**2.1.7 AMENDMENT 7: CPW**

**Glazing reconfigured to CPW South-West & West elevations**

APPROVED ELEVATION  
Drawing: 19559-CPA West Elevation

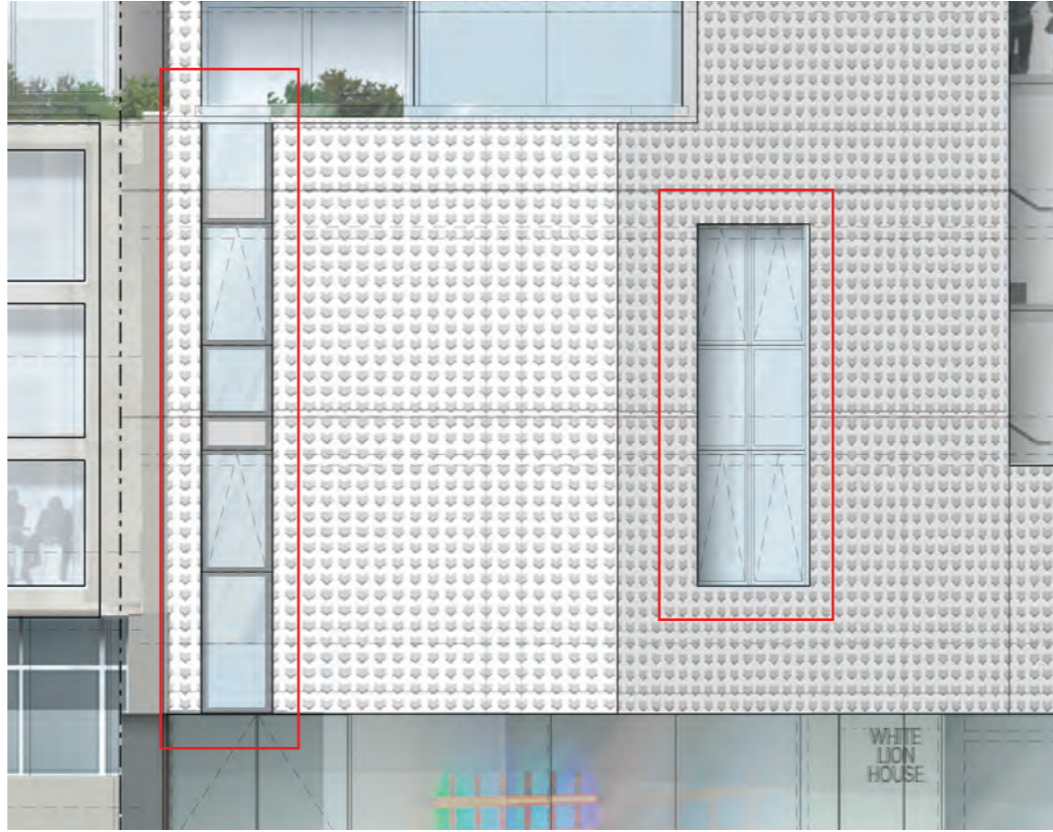
It is a mandatory requirement to provide opening windows to all apartment bedrooms. After further detailed discussions with the window suppliers it became clear that it would not be possible to achieve a full height opening window due to technical restrictions and particularly the inability to achieve necessary acoustic ratings.

It is therefore proposed to introduce a fixed glazing panel with opening lights to level 01 Mezz on the South West elevation and to the base at level 01 & 01 Mezz on the West elevation. This will ensure the glazed slot appearance is maintained whilst achieving the necessary technical performance.
